**PLANNING PROPOSAL – RR 2021 KEMPS 001 00**  
**LOT 35 DP 1214499 SOUTH WEST ROCKS - SALTWATER**

2 May 2022

### **PLANNING PROPOSAL – RR 2021 KEMPS 001 00** **LOT 35 DP 1214499 SOUTH WEST ROCKS - SALTWATER**

**Figure 1 – Water Supply Works**

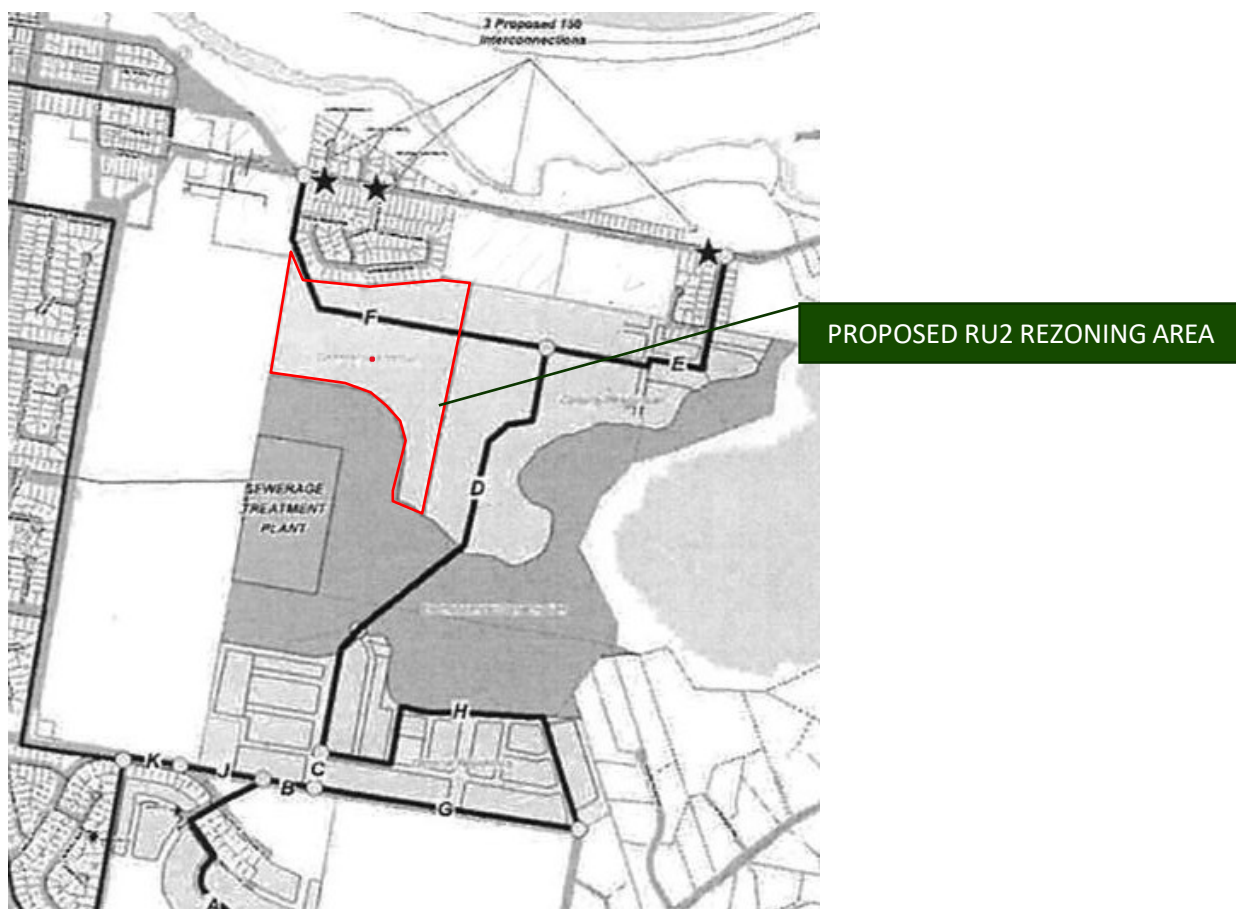
- Water supply infrastructure – relies on previous Council advice from 2017 which is not current. The water supply infrastructure required to service this, and nearby proposed developments has not been established and needs to be revisited. Council is currently

Council suggests that the advice on the water supply strategy dated 2017 is not current. Council's report and proposed infrastructure was undertaken only 5 years ago. Typical studies always look at an horizon of 20 to 30 years. Examination of the strategy shows that it includes the full development of the area subject to the rezoning as shown on the extract in Figure 1.

We have also been advised that the works outlined in the strategy are in Council's forward budget.

As such, we contend that for the purposes of the rezoning application, there is sufficient strategic certainty about the adequacy of the water supply system to supply water to the site with augmented infrastructure as per the strategy. A copy of the strategy is contained in Annexure A.

Figure A.1 – Water Supply Works

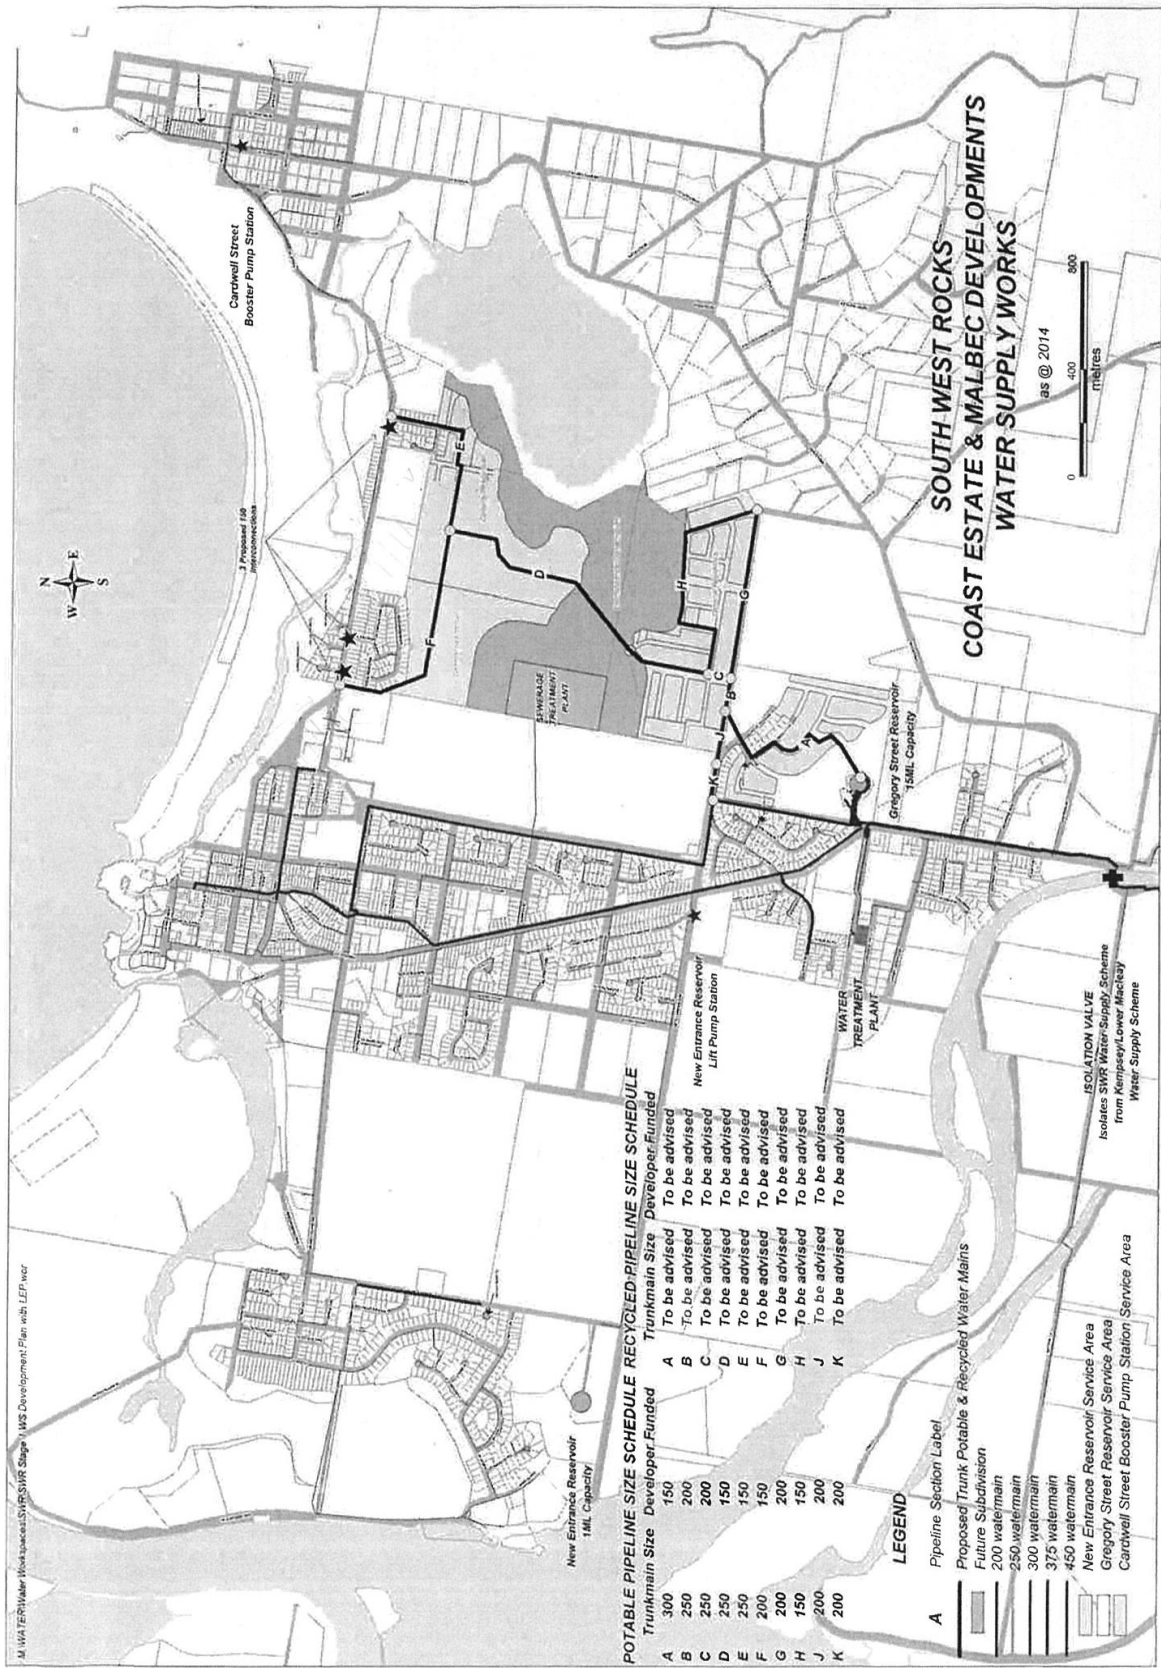
- It is noted that a previous performance test was undertaken in 2015 and an assessment has been completed using this information. Current performance test information would be preferable and Council can provide such tests at \$312.45 per test
- Minimum residual pressure in new development areas is 15m and it is preferable to be higher. It is expected residual pressure below 20m would be considered as limiting by most residents.
- The alignment of the trunk main within the subdivision staging needs to be discussed in further detail as the depictions of the trunk main in 13056 is not necessarily preferred.

Council have developed a long term strategy to supply the whole Saltwater development. The plan is shown on Figure A.1. Essentially the long term plan to supply the Saltwater area is with a 250mm watermain connected from the south from the Gregory Street Reservoir. The plan shows three watermain within the site – notated as Trunk mains D, E and F. The following sizes are indicated:

Trunkmain	Required Diameter	Equivalent size to be funded by developer. Balance of cost to be funded by Council
D	250 mm	150mm
E	250 mm	150mm
F	200 mm	150mm

It is noted that Main “F” on the figure runs through the proposed rezoning area. Council’s confirmation of its future strategy for water supply and its budgeting, is confirmed in the email contained in Figure A-2
